## ALERT SERVICE BULLETIN

**412-20-182**

**MODEL AFFECTED:** 412/412EP

**SUBJECT:** ENGINE OIL CHECK VALVE P/N 209-062-520-001,  
INSPECTION AND REPLACEMENT OF.

Figure 3. Engine Oil Check Valve Outside Diameter Measurement

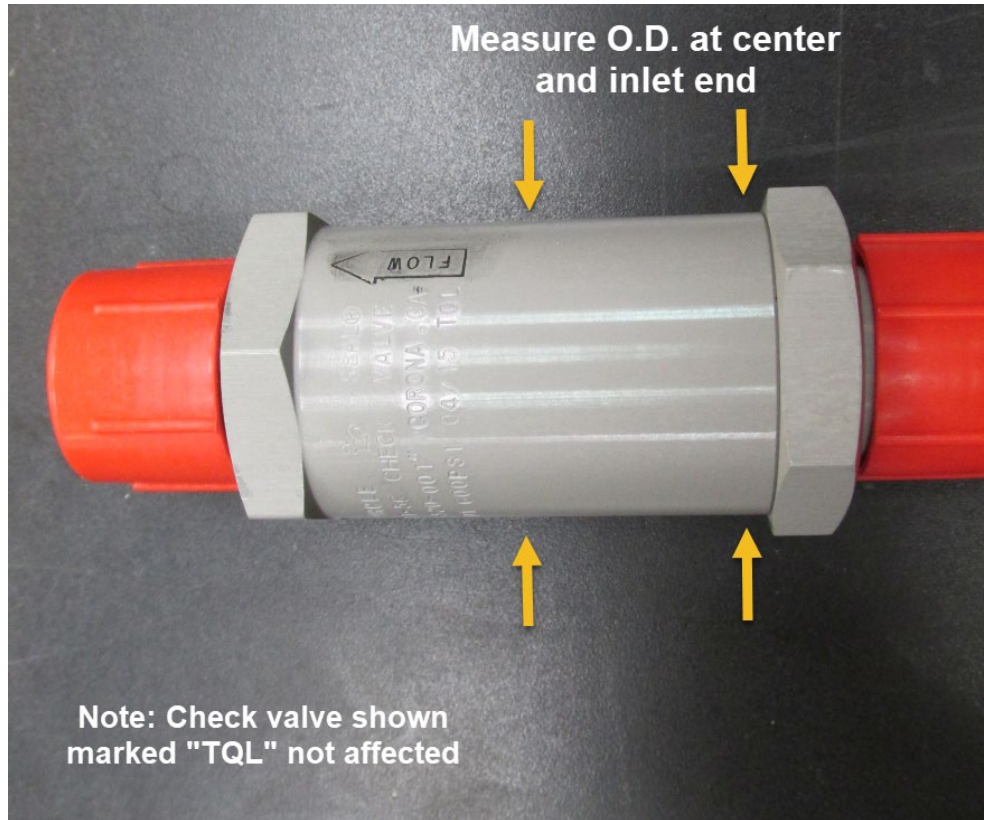
- d. If the dimension measured at the inlet end is greater than 0.003 inch (0.0762 mm) when compared to the measurement at the center, the valve will require replacement. Part III can be accomplished immediately, or Part II can be accomplished until the defective valve can be replaced in accordance with Part III.
- e. If the defective check valve is not replaced immediately, make an entry in the helicopter logbook and historical service records indicating the findings and that Part II must be accomplished every 25 flight hours or 30 days whichever comes first until Part III is accomplished.

Figure 4. Cracked Engine Oil Check Valve

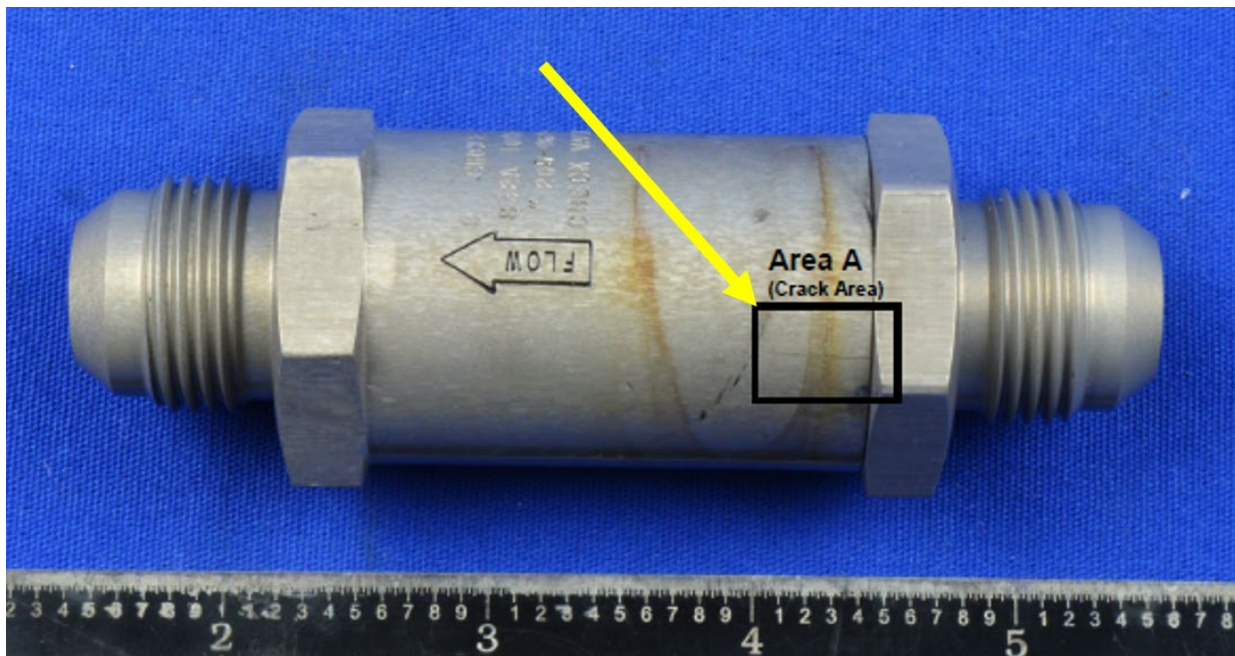
Bell recently received a report of a cracked check valve manufactured by Circor Aerospace (Circle Seal). This check valve was manufactured in 2009 which is outside of the manufacturing date range (October 2011 – March 2015) addressed by the ASB 412-15-165 Rev A. Corrective actions implemented in 2015 by Circor Aerospace to prevent cracking of the check valve housings are indicated by the “TQL” marking.

This recent check valve cracking report indicates that additional oil check valves P/N 209-062-520-001 manufactured by Circor Aerospace (Circle Seal) not having the “TQL” marking may be susceptible to cracking with time in service.
